**La Jolla Shores Planned District Advisory Board (LJSPDAB)
APPLICANT PROJECT INFORMATION FORM**

- Project Tracking System (PTS) Number/Accela "PRJ" Number and Project Name (only submitted projects to the Development Services Department can be heard as action items):
PRJ-1085883

- Project description:
 - **SITE DEVELOPMENT/COASTAL DEVELOPMENT/NEIGHBORHOOD DEVELOPMENT PLANS**
 - 1 CONSOLIDATED LOT SPLIT INTO 6 INDIVIDUAL LOTS
 - EACH LOT TO CONSIST OF 1 SINGLE FAMILY DWELLING

TENTATIVE MAP NO. 3213966

A408
LOT 4 - EXTERIOR ELEVATIONS

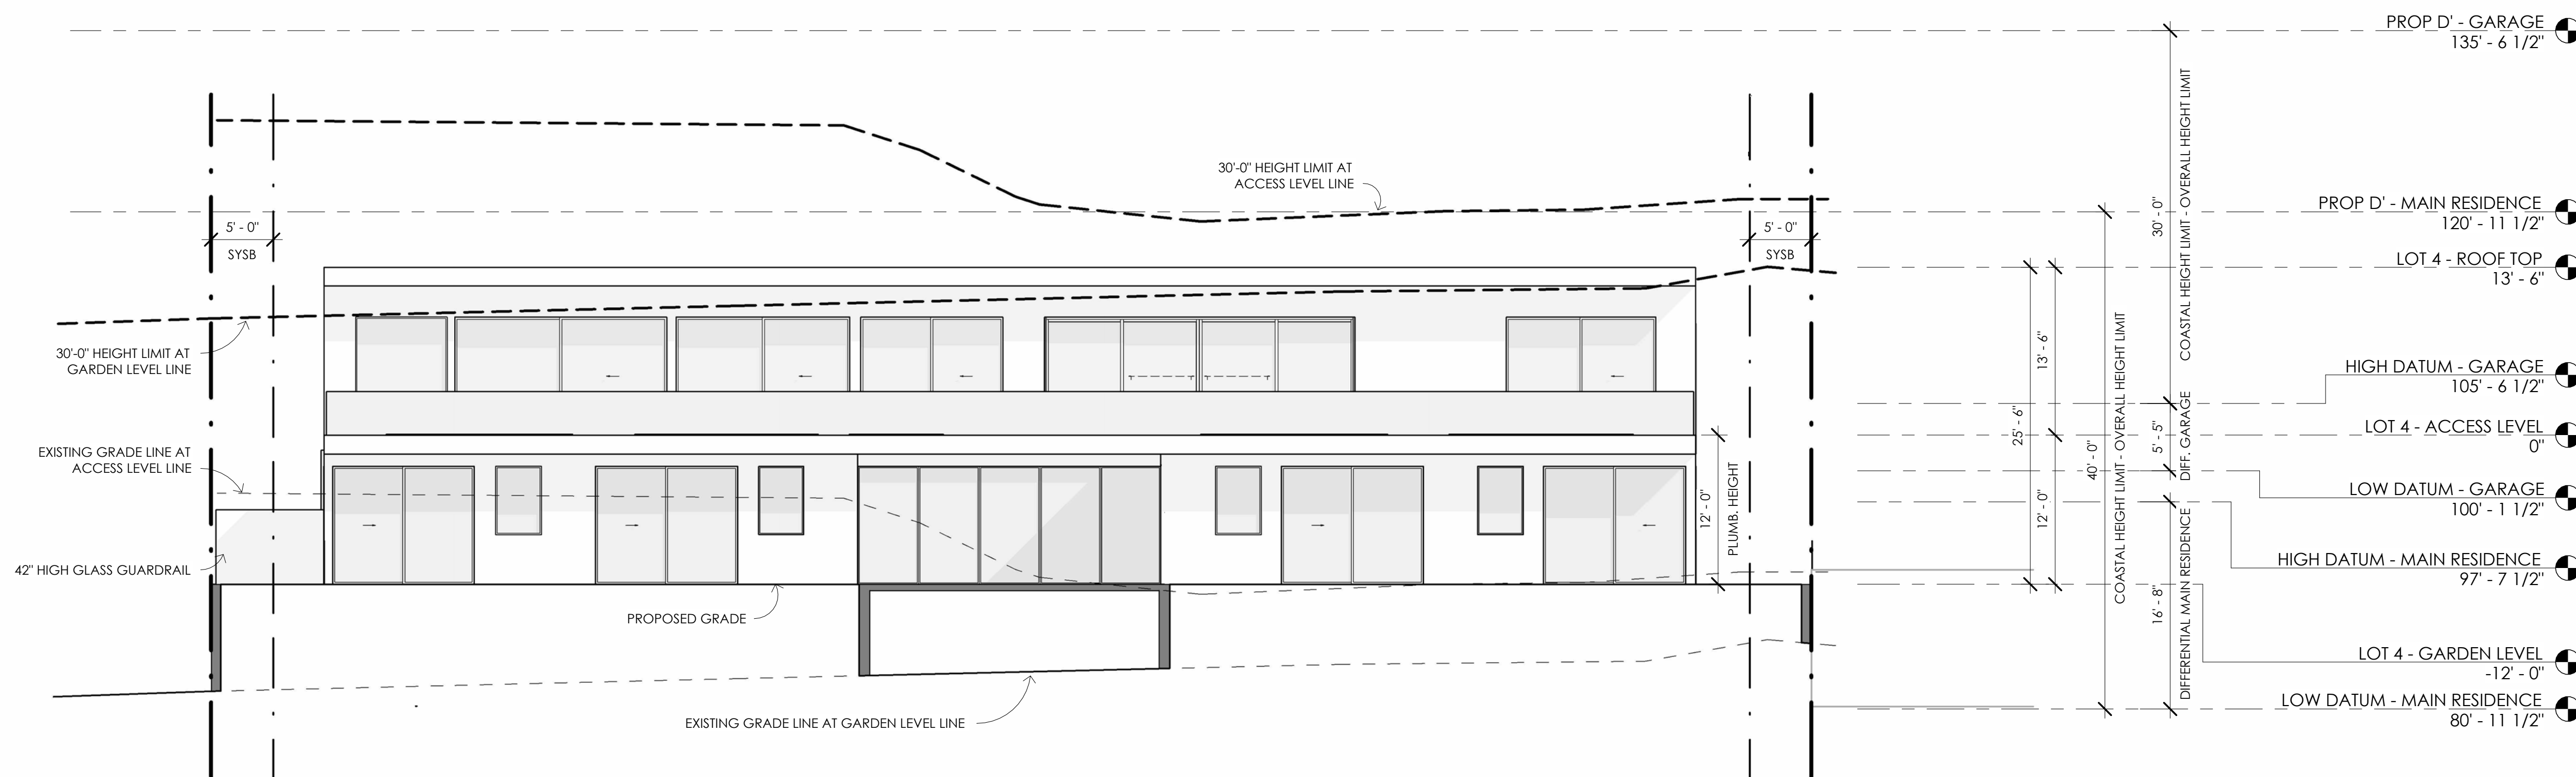
Sheet A407 North Elevation -Section 4 – Please provide cross-sections to understand the relationship between the grade and the highest point of the structure. At each point, the structure may not exceed 30’. Please review exceptions to §113.0270(4) and present where these are applied on the site.
